Village of Bayside
9075 N. Regent Rd.
Architectural Review Committee Meeting
October 7, 2019
Village Board Room, 6:00pm

**ARCHITECTURAL REVIEW COMMITTEE
AGENDA**

- A. Shed-8 feet by 10 feet and patio awning-12 feet by 20 feet
122 E Fairy Chasm Rd
016-0002-000
- B. Service door, modification of existing windows and doors, and
extension of stoop
9605 N Lake Dr
017-0500303-000
- C. Garage-72 feet by 50 feet
1111 E Brown Deer Rd
055-9999-000

Blot of Survey

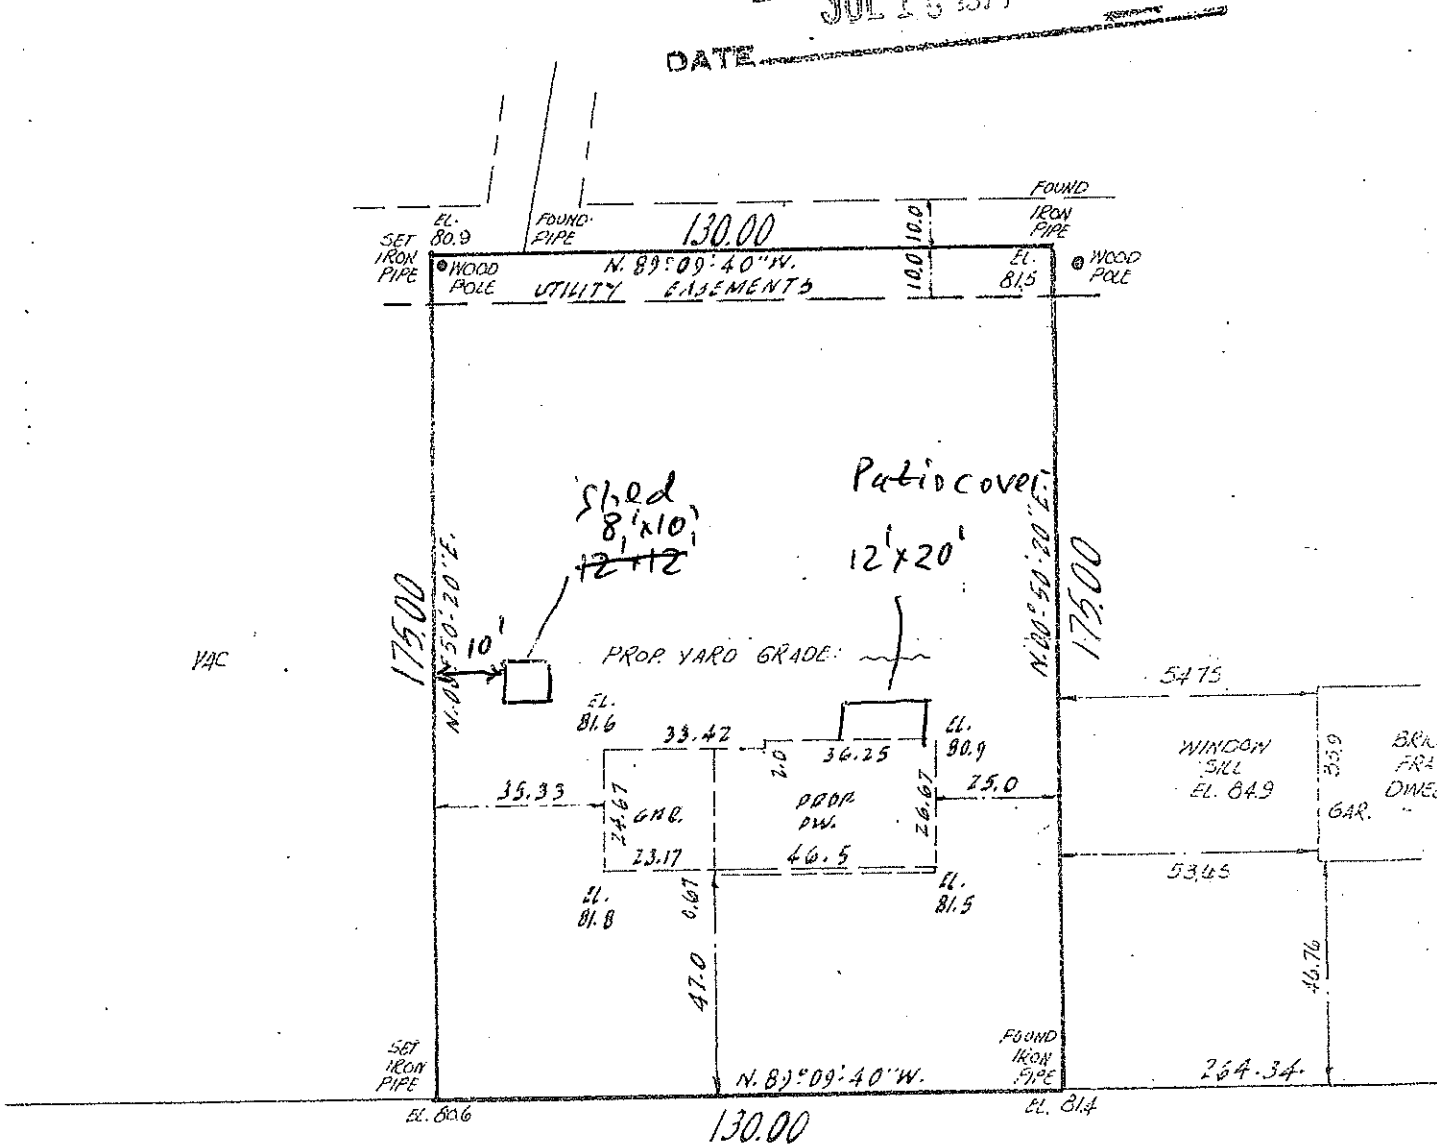
Revised shed location complies with setback requirements.

NEW SHED LOCATION COMPLIES WITH VILLAGE CODE.

New awning will require structural review in order to receive a building permit. Kit system is being purchased from Amazon. Local snow and wind loads will need to be verified. ARC review is for appearance only. ARC to give opinion regarding metal awning kit appearance.

PLAT OF SURVEY

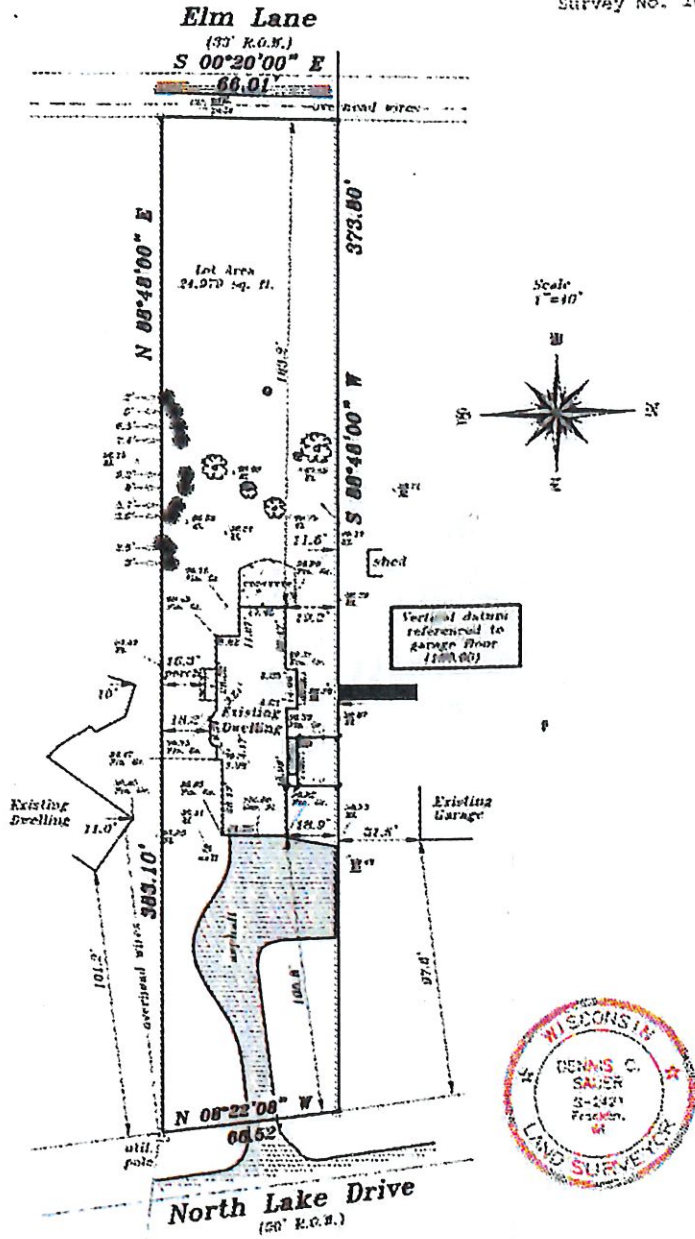
ARC review is for exterior aesthetics only.

Windows and doors will need to be inspected for proper structural headers, clear opening dimensions, and safety glazing locations. Provide additional information with building permit application.

New dining room walls that extend into the existing garage will need to be protected against fire per SPS 321.08. Provide additional information with building permit application.

New dining room floor bears on existing garage slab. New dining room section shows second floor above new dining room space. Structural verification will be required. Provide additional information with building permit application.

Project is approved for ARC review.

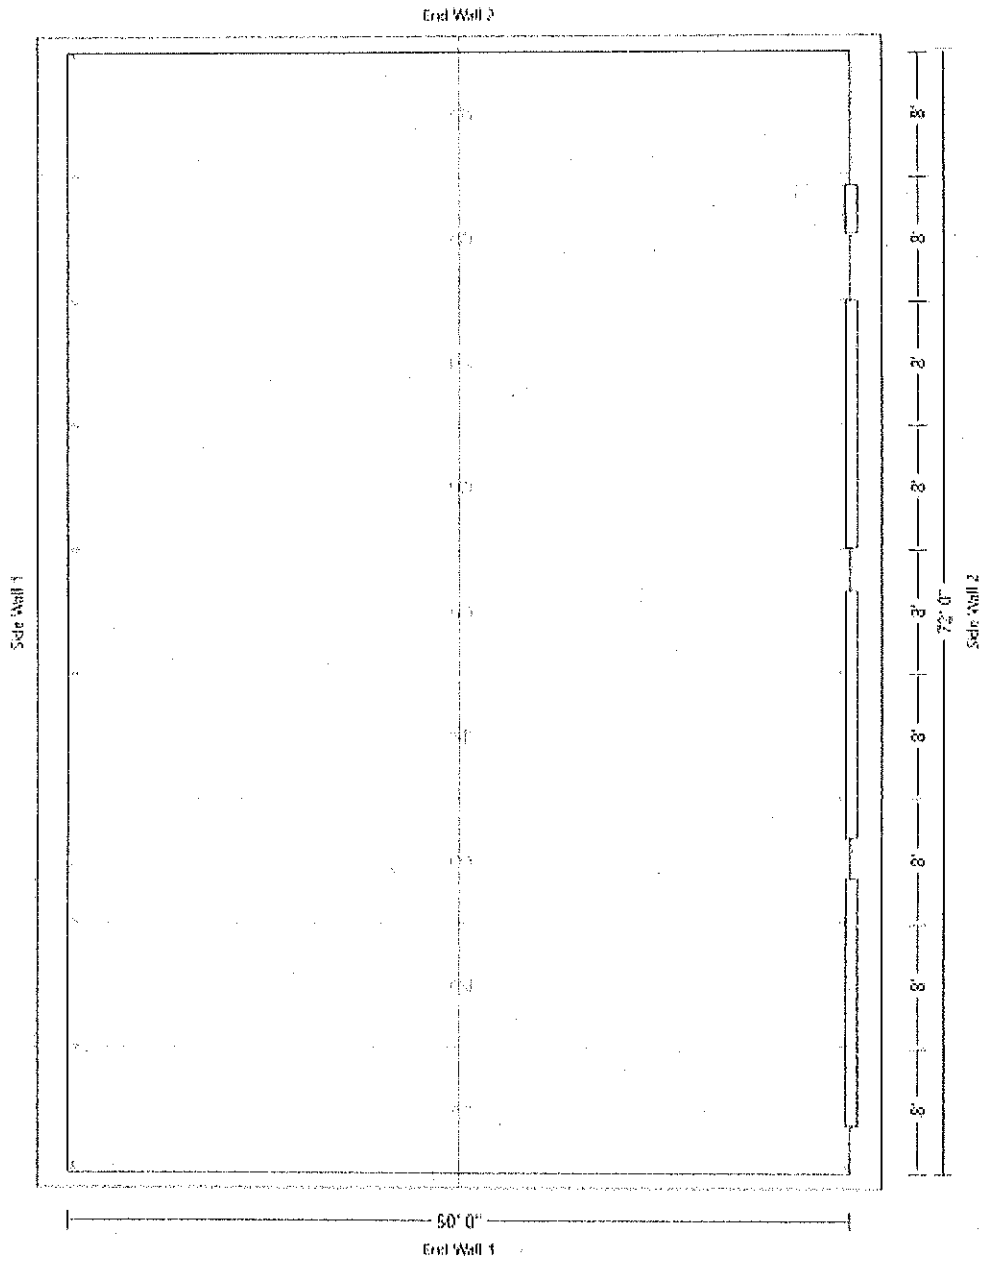
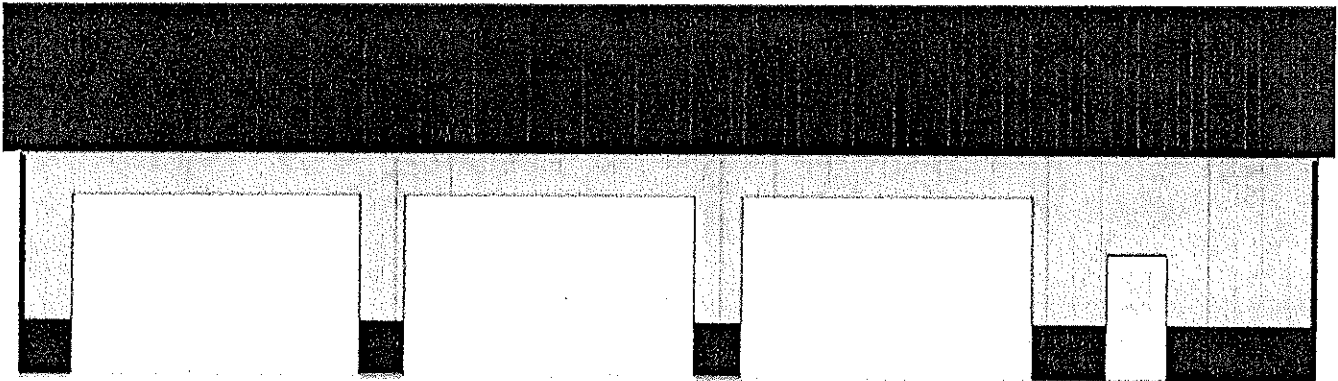
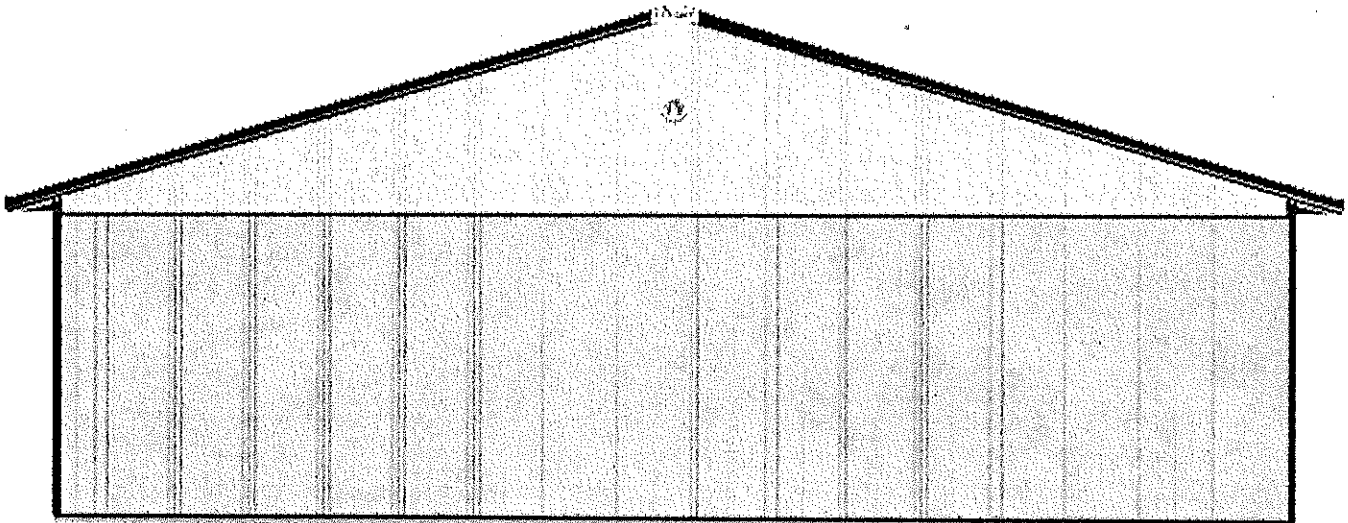
Reviewer believes the exterior improvements proposed for this project significantly improve the existing appearance of the commercial building and provide a more pleasing exterior aesthetic. Reviewer believes this project complies with the following Village Code sections:

Architectural Review Committee shall make final determination of approval of the proposed roof design relative to existing nearby structures.

Building review is required. Submit plans with a complete SBD118 plan review application form.
